DR 400	Type 5520	SB No. 55
DR 600	Type 5530	SB No. 70
DX-D 100	Type 5410	SB No. 98
DX-D 300	Type 8207	SB No. 102
DX-D 400	Type 5420	SB No. 72
DX-D 500	Type 8206	SB No. 57
DX-D 600	Type 5430	SB No. 113
DR Retrofit	Type 5400	SB No. 63

Service Bulletin

**2nd revised version: Update instructions moved to Detector Service Manual
DX-D 10/20/Fixed detector software VRN 7.5 and Intel I210-T1
network card introduced**

Figure 1

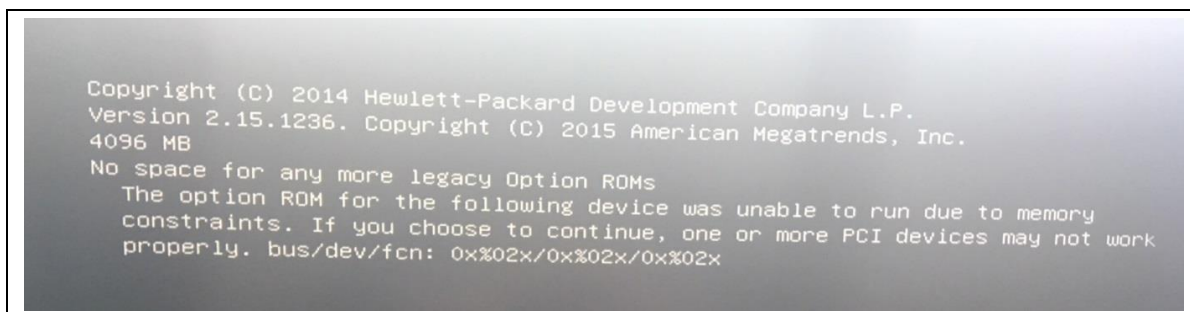
BIOS issue When plugging multiple Intel® I210-T1 network cards in a HP rp5810, the following BIOS message appears.

Solution This can be solved by a BIOS settings adaptation. For details refer to DX-D 10 / DX-D 20 / DX-D Fixed Detector - Service Manual, Document ID [41222172](#), section *Troubleshooting*.
